Revisions to 10/30/98  
TPE PSA report

February 8, 1999

RE: Summary of Findings  
Mission Valley Rock  
799 Athenour Way  
Sunol, Ca 94586  
Project Number 384

SITE PLAN:  
 GROUNDWATER ELEVATION AND GRADIENT MAP (06/23/98)

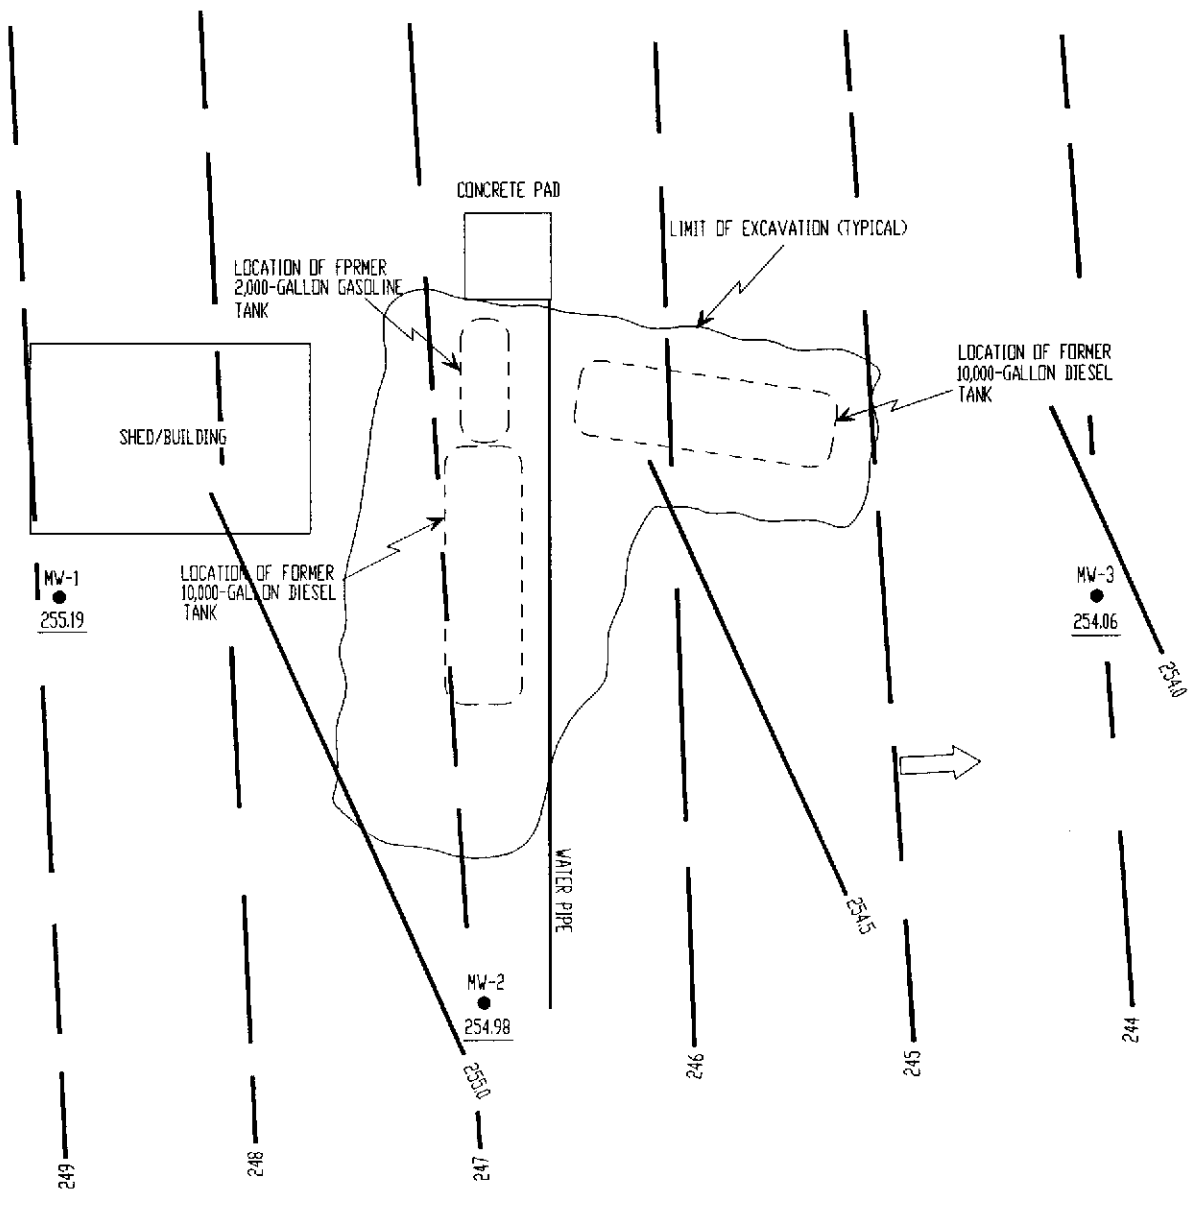
- Groundwater gradient for the upper boundary of the confined aquifer encountered during drilling appears to be to the east at a gradient of 0.046. During the initial groundwater sampling event of 6/23/98, 5 days later, static water level was measured between 1.32 and 2.66 BGS. ~~Flow direction was to the northeast at approximately 0.012~~ Except for being noticeably higher in the well bore, due to the aquifer being open to the atmosphere, gradient and direction were similar between confined and unconfined conditions. ~~Based on present information flow direction is toward the river to the east.~~

SITE PLAN:  
VADOSE ZONE TPHD CONCENTRATIONS

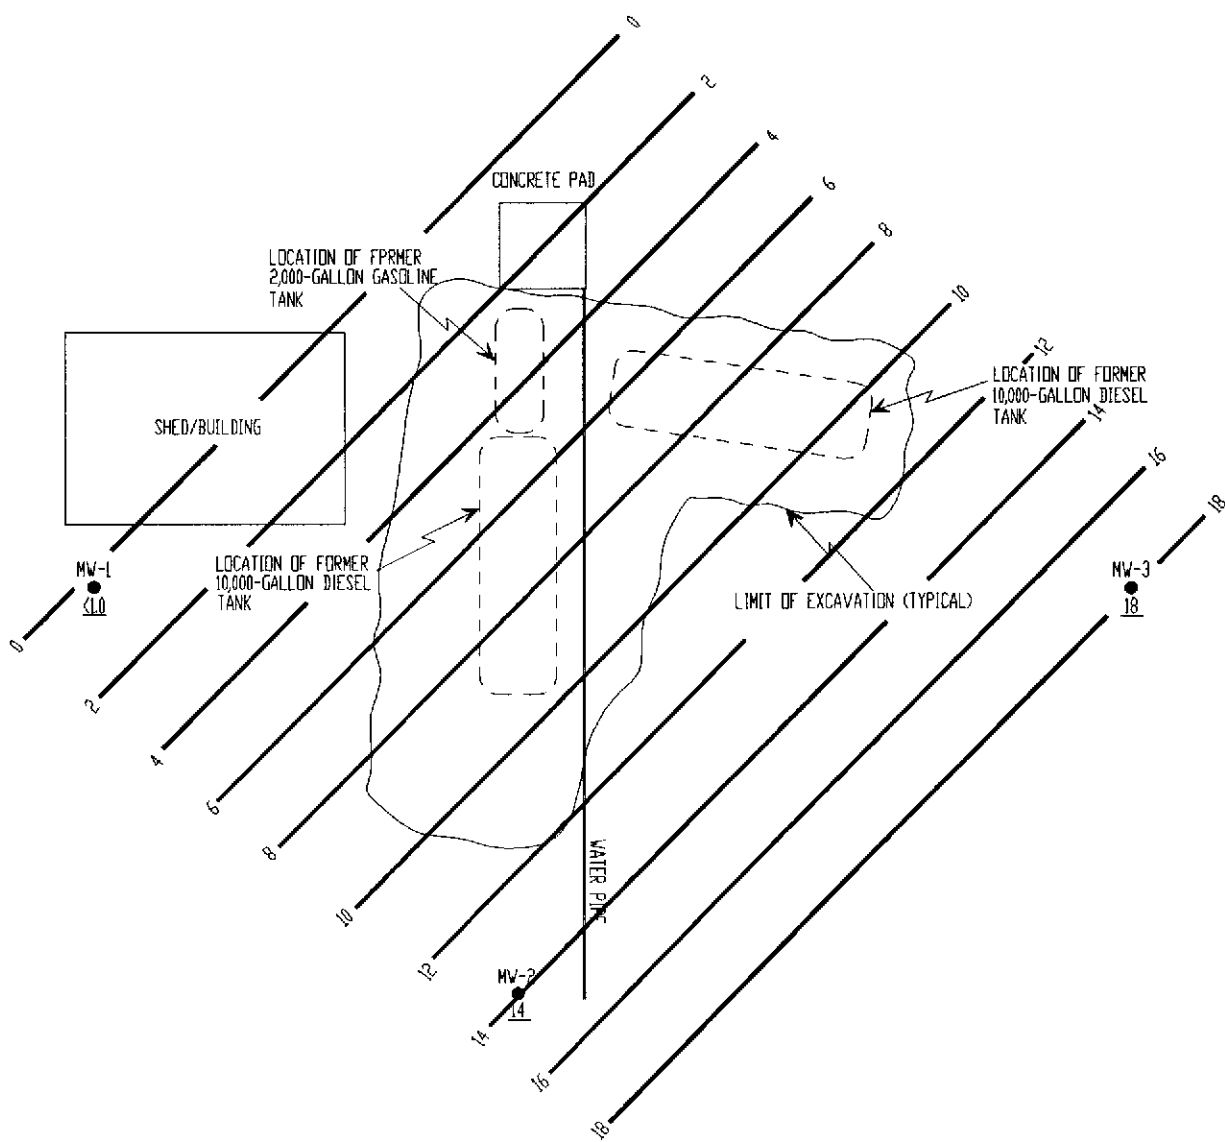
Well	Depth to water	Soil Sample Analyzed	ppm diesel
MW-1	7-8 feet	15-15.5 feet	<1
MW-2	9-10 feet	10-10.5 feet	14
MW-3	13 feet	20-20.5 feet	18

It appears, the since saturated samples were analyzed, the results may reflect groundwater impact rather than soil impact of diesel. In other words, the porous soil particles may have been absorbing diesel from the water. Soil samples above the confined aquifer, in the overlying clay may not be impacted. MW-2 may be a special case in that the shallow "utility trench" sand may be directly impacted from the nearest UST, and thus impacted the immediately underlying clay, although there again water depth is nearly coincident with the soil sample depth.

Well No: MW-1, Mission Valley Rock, 799 Athenour Way, Sunol; Construction Diagram

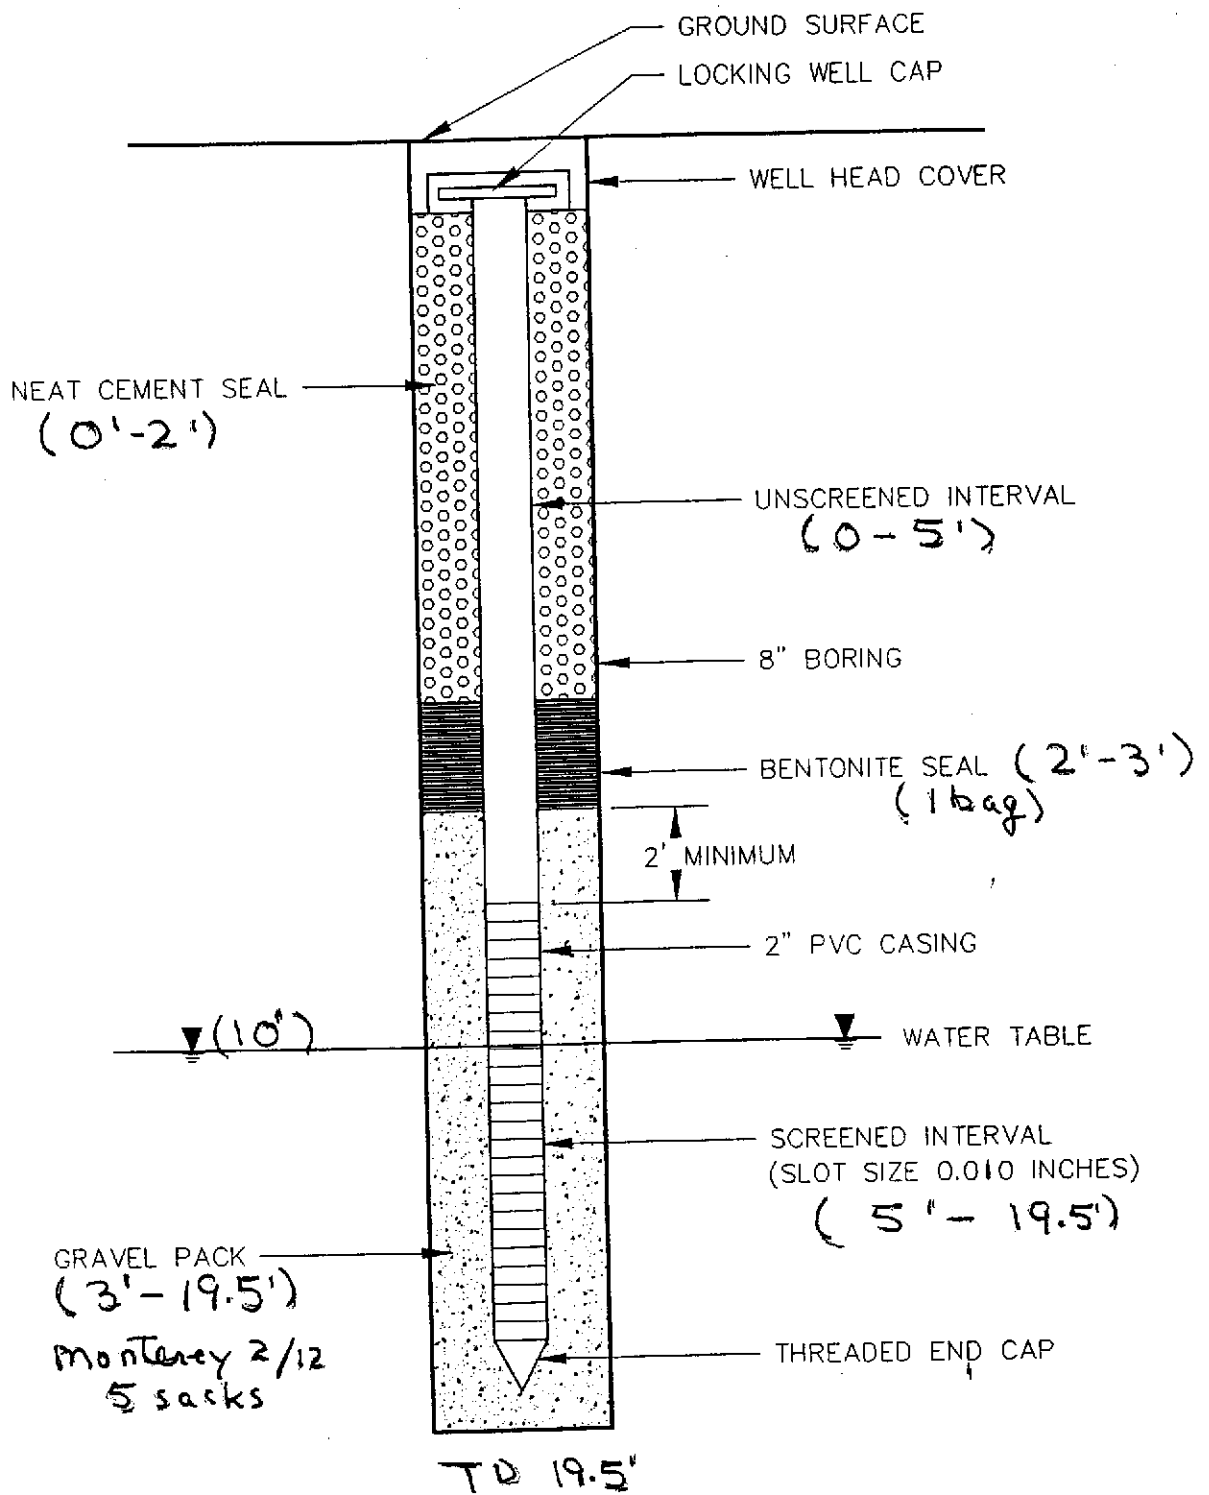
- Both the Log of Exploratory Boring and Construction Diagram, dated 6/18/98, have been neatly rewritten to be more legible(MW-1, MW-2, MW-3).
- ~~The aquifer appears to be a confined aquifer in the vicinity of the well locations.~~ Top of the aquifer would correlate at the approximate base of a clay unit (top of sand unit) which extends to between 6.5 feet at MW-1(west) to 13 feet at MW-3(east).

- All monitoring wells were completed to acceptable standards based upon the conditions encountered at the time of drilling. ~~Screen intervals, gravel pack, bentonite seal, cement grout, etc. were all properly placed.~~ Subsequent groundwater sampling events should reflect site groundwater conditions.
